UNITED STATES PATENT AND TRADEMARK OFFICE

Office Action Summary

10/696,661

NEUDORF, BRENT

FIG 1: Chubb et al (original)

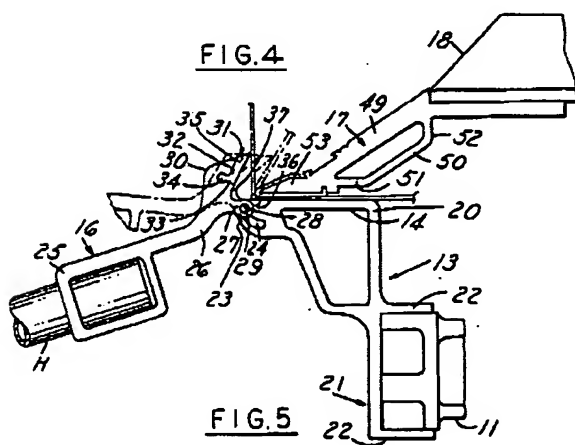
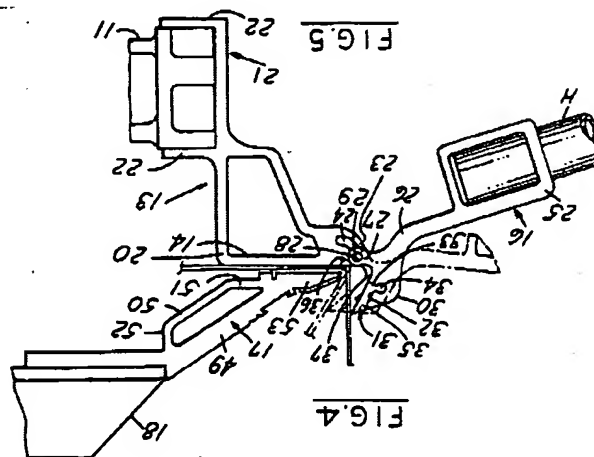
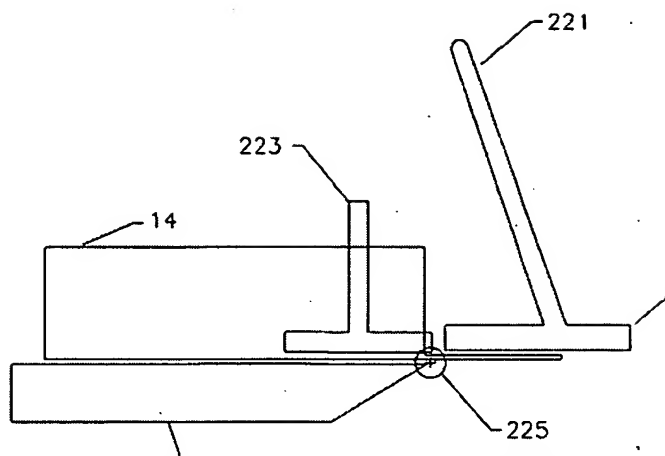
1. Determining the scope and contents of the prior art.
 2. Ascertaining the differences between the prior art and the claims at issue.
 3. Resolving the level of ordinary skill in the pertinent art.
 4. Considering objective evidence present in the application indicating obviousness or nonobviousness.
1. Claim 17 is rejected under 35 U.S.C. 103(a) as being unpatentable over Chubb et al (U.S. Patent # 6,085,569). Chubb et al discloses a heavy duty sheet bending brake having a hold down (fixed member, 13) with a clamping surface (14), a panel support (anvil member, 17) and a brake

plate (bending member, 16) with a brake handle (handle, H). Chubb et al discloses the claimed invention except for wherein a tool adapted to hem an exposed tongue has an angled panel support such that a roofing panel is secured on the panel support by the hold down and pressure is applied to the tongue by the brake handle so that the tongue is bent around a brake pivot on an end of the panel support. It would have been obvious to one having ordinary skill in the art at the time the invention was made to rotate the support panel and the hold down by 180 degrees to bend the tongue downward instead of upward as disclosed by Chubb et al, since it has been held that a mere reversal of the essential working parts of a device involves only routine skill in the art. (See FIG 1-3)
